Access Compliance Report
Public Rights-of-Way
(Curb Ramps)

Main Street: IRVINE_AVE | **Cross Street: MESA_DR** | **Location: SW**

ADA ID: RPAT220128133627 | **Ramp Type:Type 1 - Perpendicular Diagonal Initial Pass/Fail: Fail** | **Overall Compliance: No** | **Severity Score: 2**

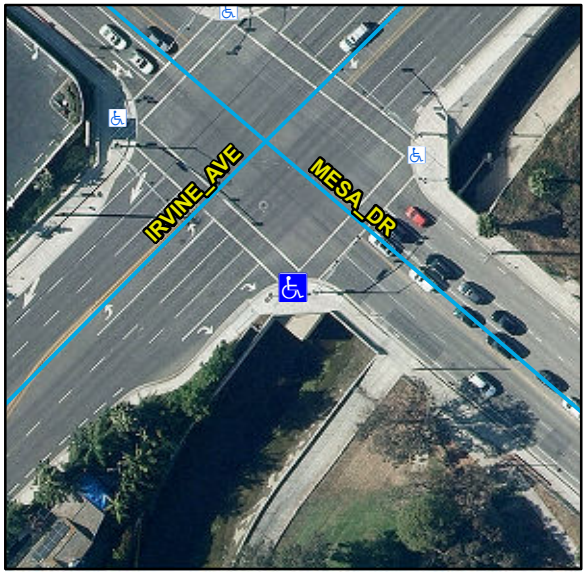
Compliance	Description	Data	Compliance	Description	Data
N/A	Ramp Length (in)	**109**	**N/A**	Flare Type LT	
Yes	Ramp Width (in)	**50**			**N/A**
Yes	Ramp Run Slope (%)	**6.3**	**N/A**	Flare Slope LT (%)	**N/A**
No	Ramp Cross Slope (%)	**2.9**	**N/A**	Flare Traversable LT	**N/A**
N/A	Landing Present	**N/A**	**N/A**	Flare Type RT	
N/A	Landing Length (in)	**N/A**			**N/A**
N/A	Landing Width (in)	**N/A**	**N/A**	Flare Slope RT (%)	**N/A**
N/A	Landing Run Slope (%)	**N/A**	**N/A**	Flare Traversable RT	**N/A**
N/A	Landing Cross Slope (%)	**N/A**	**N/A**	DWS Provided	**N/A**
N/A	Landing Movement Obstructed?	**N/A**	**N/A**	DWS Contrast	**N/A**
	Landing Movement Type	**N/A**	**N/A**	DWS Length (in)	**N/A**
N/A	Landing Shared	**N/A**	**N/A**	DWS Full Width	**N/A**
N/A	Clear Space	**Yes**	**N/A**	DWS Offset Left (in)	**N/A**
N/A	Clear Space To Crosswalk (in)	**48**	**N/A**	DWS Offset Right (in)	**N/A**
N/A	Marked Crosswalk 1	**Yes**	**N/A**	Marked Crosswalk 2	**Yes**

Remove & Replace Curb Ramp With Two New Directional Ramps or Equivalent.

R304.5.3, STD 1115
